CNL-16-048

Browns Ferry Nuclear Plant, Units 1, 2, and 3  
Renewed Facility Operating License Nos. DPR-33, DPR-52, and DPR-68  
NRC Docket Nos. 50-259, 50-260, and 50-296

Subject: **Proposed Technical Specifications (TS) Change TS-505 - Request for License Amendments - Extended Power Uprate (EPU) - Supplement 7, Responses to Requests for Additional Information**

**Response to NRC Requests for Additional Information**

**Figure 2.5-1 Appendix R Case Max SPT (EPU) Fire Event Suppression Pool Temperature**

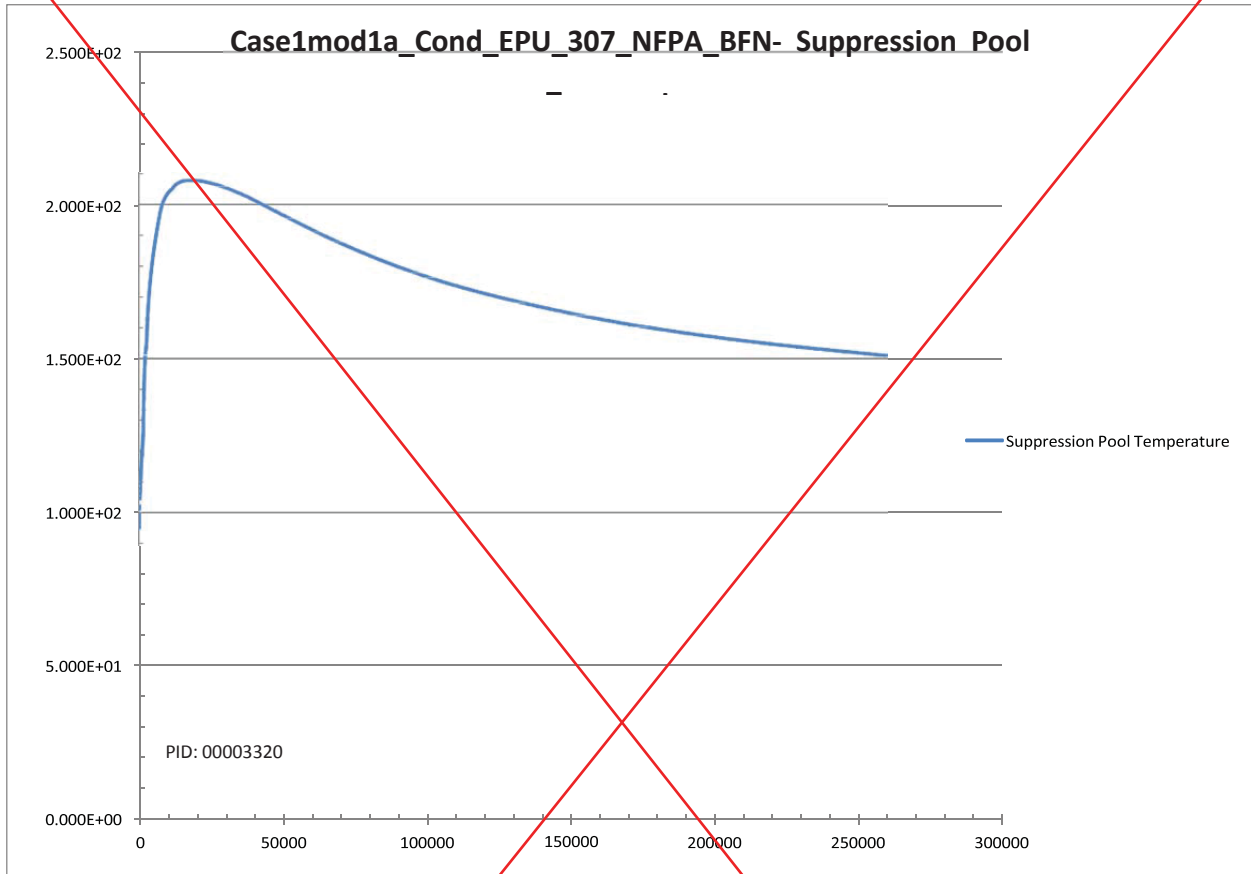
**Case Max SPT** (See Tables 2.5-1, 2.5-2, 2.5-3 and Figure 2.5-1)

This is the worst-case scenario for peak SPT and is used as an input in the analysis for available NPSH for the safe shutdown system pumps. Analyses show that containment accident pressure credit is not required to ensure adequate pump NPSH to mitigate a fire event. (See Section 2.6.5.2 and EPU LAR Attachment 39.)

**Figure 2.5-1 Appendix R Upper Plenum Pressure  
Case 1 - 3 MSRVs Opened at 25 Minutes**

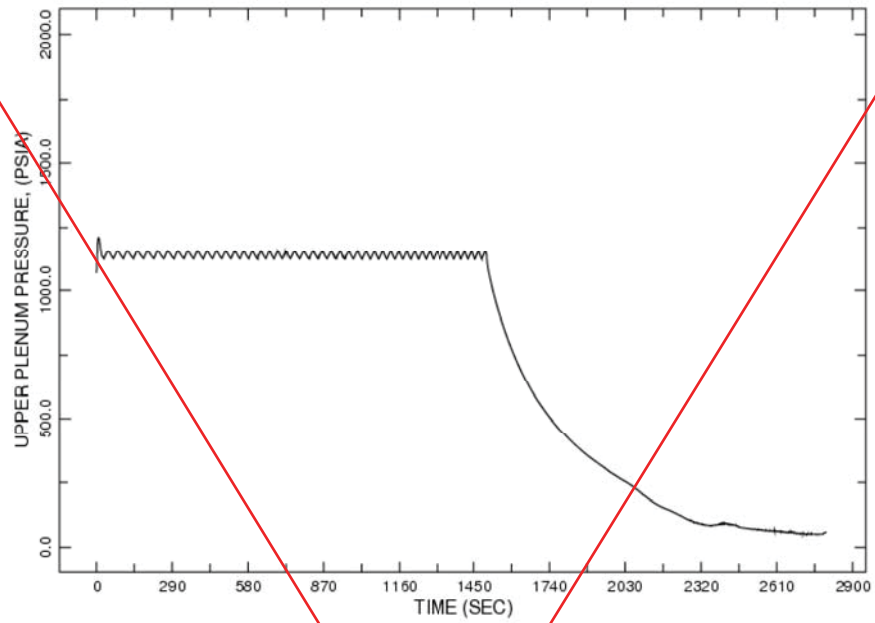
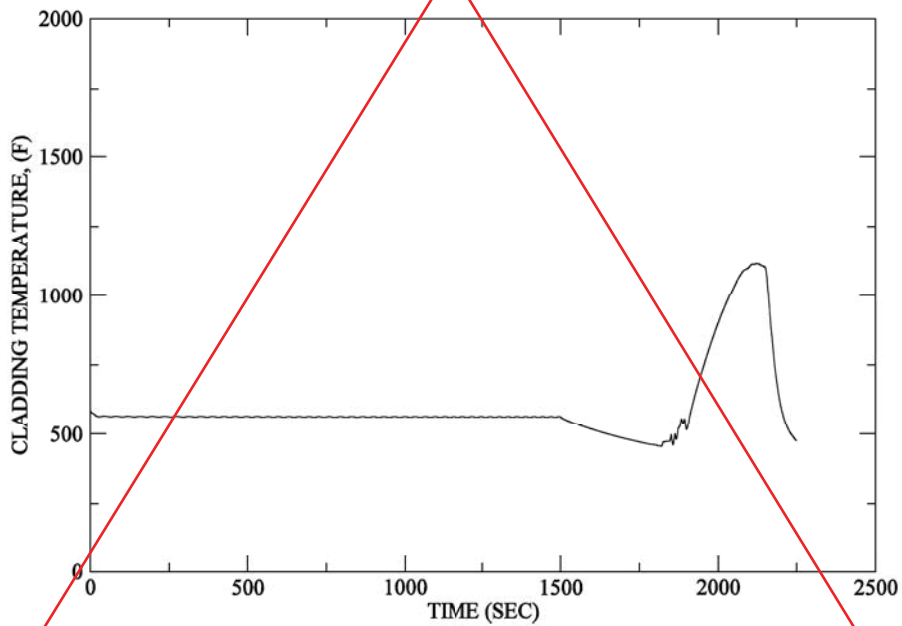
Figure 2.5-1	<del>Appendix R Upper Plenum Pressure Case 1 - 3 MSRVs Opened at 25 Minutes.....</del>	<del>25</del>
Figure 2.5-2	<del>Appendix R PCT Rod Surface Temperature Case 1 - 3 MSRVs Opened at 25 Minutes.....</del>	<del>25</del>
Figure 2.5-3	NFPA 805 Upper Plenum Pressure 11 MSRVs Open.....	26
Figure 2.5-4	NFPA 805 PCT Rod Surface Temperature 11 MSRVs Open .....	26
Figure 2.6-1	Time-integrated Containment Hydrogen Generation.....	30
Figure 2.6-2	Uncontrolled H <sub>2</sub> and O <sub>2</sub> Concentrations in Drywell and Wetwell.....	31
Figure 2.6-3	Drywell Pressure Response to CAD Operation without Venting .....	32
Figure 2.6-4	CAD System Nitrogen Volume Requirement .....	33
Figure 2.8-1	Comparison of Hot Excess Reactivity for EPU and CLTP Conditions (nominal EOC N-1).....	139
Figure 2.8-2	OPRM (Option III) Trip-Enabled Region.....	140
Figure 2.8-3	Limiting Cycle Specific DIVOM Results for ATRIUM 10XM EPU Reference Cycle.....	141

The primary parameter calculated in the cases was PCT. The results from these calculations are provided in Table 2.5-1, Figure 2.5-1, and Figure 2.5-2.

The results of the Appendix R analysis for AREVA fuel at EPU conditions demonstrate that fuel cladding integrity and reactor vessel integrity will be maintained using the licensee specified and validated operator response times. Case 1 is the limiting case. The PCT is 1119°F and the peak vessel pressure is 1224 psia, both of which remain below the acceptance limits of 1500°F and 1375 psig.
